IN THE MATTER of Application for Resource Consent
under Section 88 of the Resource
Management Act 1991

BY **NZ HORIZON HOSPITALITY
GROUP LIMITED**

LUC 2017-48 and SUB 2017-26

RESPONSE TO ANDREW CARR EVIDENCE

LEVEL 4

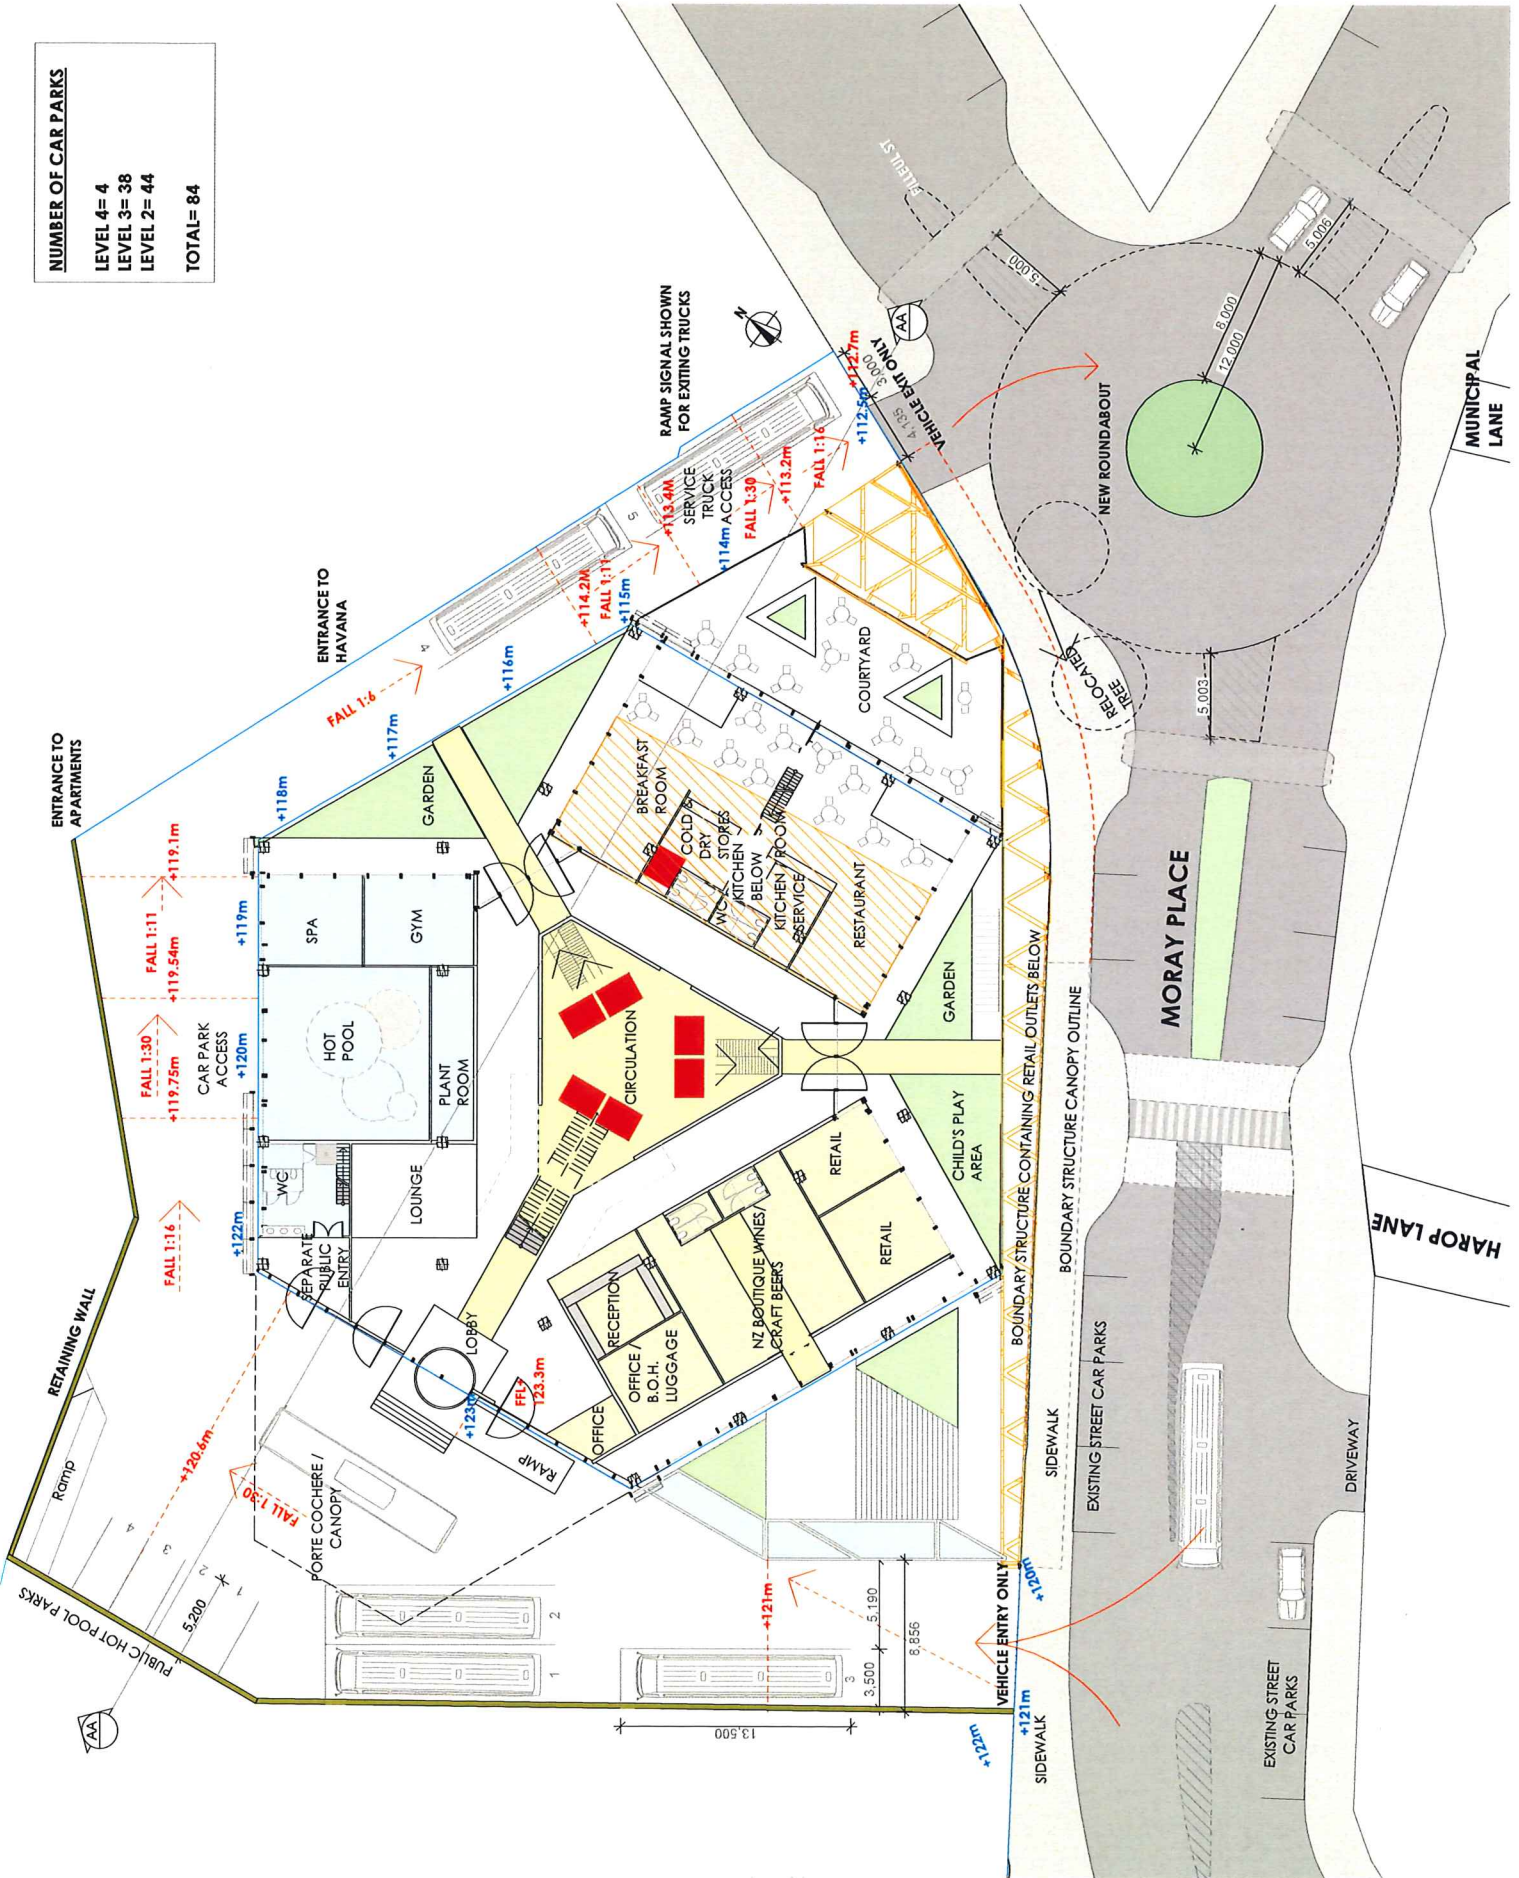
7. However, if the Commissioners are of a mind to accept Mr Carrs assessment, it should be noted that the parking supply has increased with the new plans to 86 car parking spaces on site.

LEVEL 2

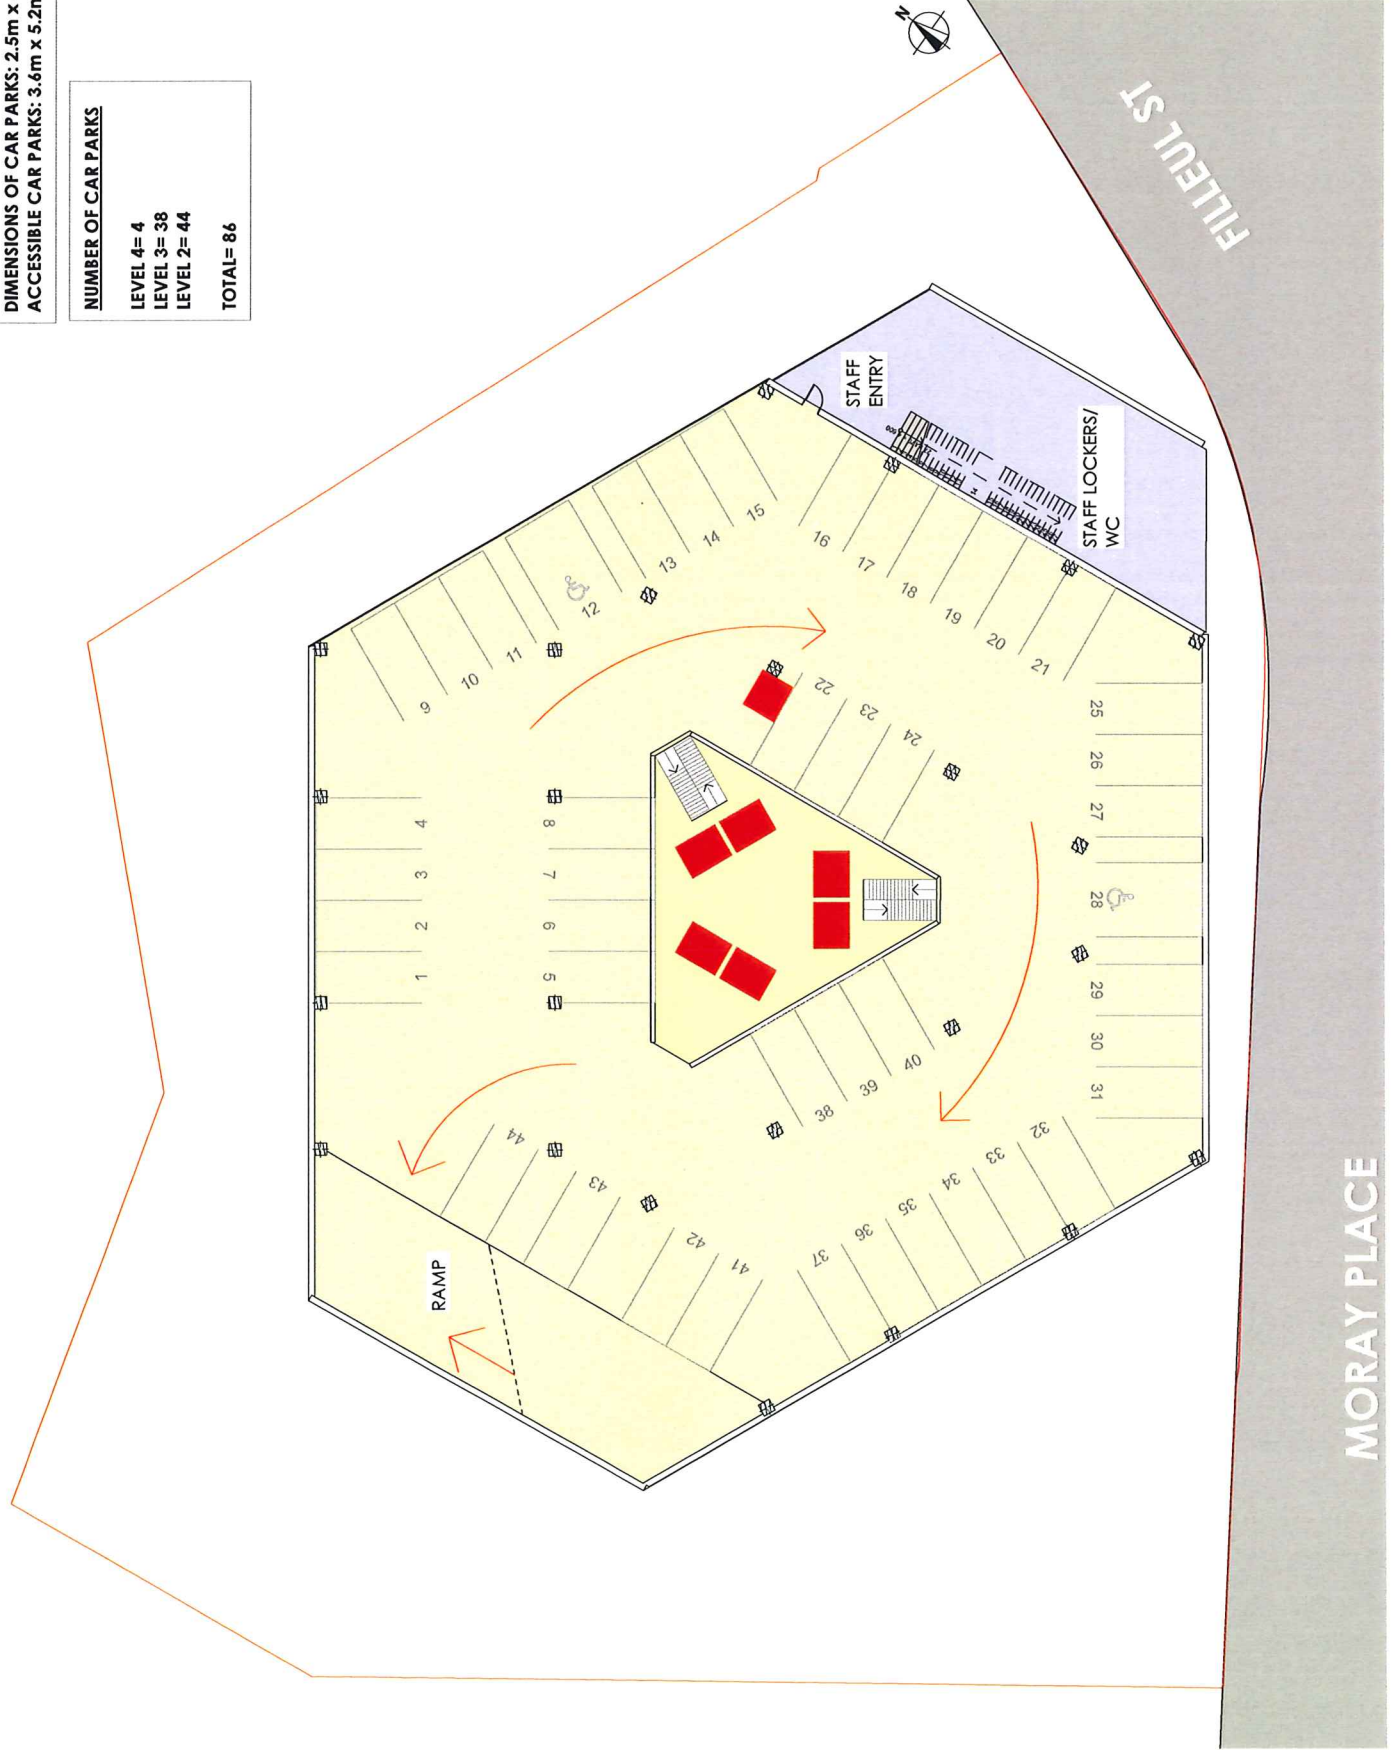
2. This was the point that Mr Carr considers critical to the functioning of the hotel. I accept the issues identified are worthy of review and a new design for the internal parking layout and access has been prepared which shows that a solution that complies with industry standards can be demonstrated. There may be other solutions that will also function appropriately and these can be assessed during detailed design to ensure the optimal solution has been prepared. Noting that details will evolve as the structural engineering design proceeds, items such as column spacing for example may change allowing for additional carparking spaces or requiring different manoeuvre paths within the building. Hence, a solution that demonstrates an acceptable design is available is required at resource consent stage with further refinement for building consent in accordance with any conditions imposed at resource consent. These new plans demonstrate an acceptable design.
